RE: St. Lucie Units 1 and 2  
Docket Nos. 50-335 and 50-389  
Renewed Facility Operating Licenses DPR-67 and NPF-16

Response to Request for Additional Information Regarding License Amendment Request to Allow Performance of Selected Emergency Diesel Generator (EDG) Surveillance Requirements (SRs) During Power Operation

Response to Request for Additional Information (RAI)  
Regarding St. Lucie Unit 1 and 2 License Amendment Request to  
Allow Performance of Selected Emergency Diesel Generator  
Surveillance Requirements During Power Operation

ST. LUCIE UNIT 2  
PROPOSED TECHNICAL SPECIFICATIONS PAGE (MARKUP)

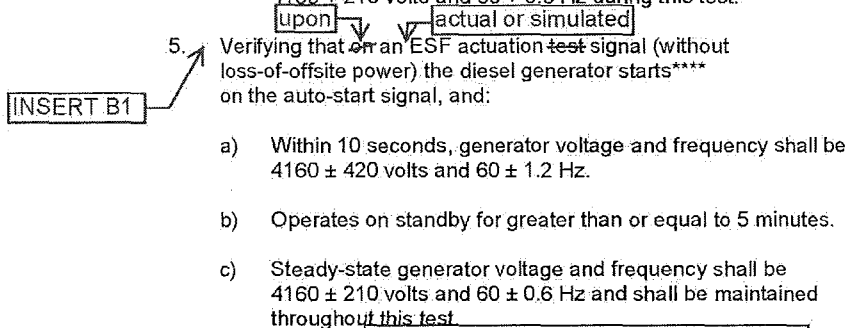
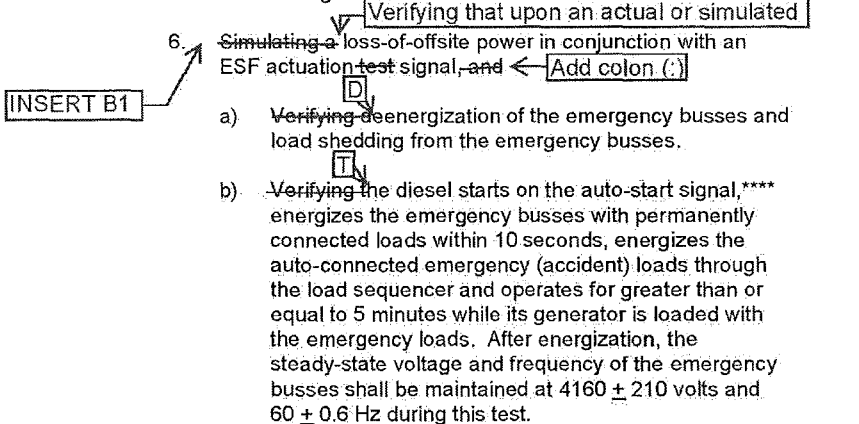
The proposed change removes the simulated signal requirement from SR 4.8.1.1.2.e.3/5/8/9 (Unit 1) and SR 4.8.1.1.2.e.4/6/9/10 (Unit 2) to accommodate the proposed NOTE crediting unplanned events that satisfy the SR. The above SRs currently require simulating a LOOP or a LOOP in conjunction with an Engineered Safety Feature actuation signal. However, it is not clear how the subject SRs will be performed without an unplanned event and simulated signal during their surveillance frequencies. It appears that the subjected SRs will not be performed if there is no actual event during their surveillance frequencies. Please provide a discussion of how the proposed change would ensure that the above SRs are met.

In Reference 1, FPL proposed removing the simulated signal requirement from SRs 4.8.1.1.2.e.3/4/5/8/9 (Unit 1) and from SRs 4.8.1.1.2.e.4/5/6/9/10 (Unit 2) to accommodate the addition of a NOTE crediting unplanned events that satisfy the SRs. However, to assure the application of simulated signals remains an acceptable method of demonstrating operability, FPL hereby withdraws the request to remove the simulated signal requirement from the subject SRs and proposes instead to employ the phrase "actual or simulated". With this change, the SRs will continue to be performed by introducing simulated LOOP, ESF and LOOP coincident with ESF signals to the EDG actuation logic circuitry, as appropriate. The SRs will be deemed complete for the corresponding surveillance periods upon demonstration of satisfactory EDG performance in response to the simulated signals. In the unlikely event of a valid LOOP, ESF or LOOP coincident with ESF signal, the proposed NOTE in Reference 1 authorizes credit to be taken for completion of the applicable SRs provided satisfactory EDG performance is demonstrated during the event. However, crediting EDG performance during an unplanned event will neither affect performance of the next scheduled surveillance nor the introduction of simulated signals to verify EDG operability during the next scheduled surveillance. The proposed change is consistent with the Combustion Engineering STS (Reference 3) for the subject SRs whereby each specify the phrase "actual or simulated" and each contain the NOTE proposed in Reference 1 allowing credit for unplanned events that satisfy the SR.

INSERT A

INSERT A
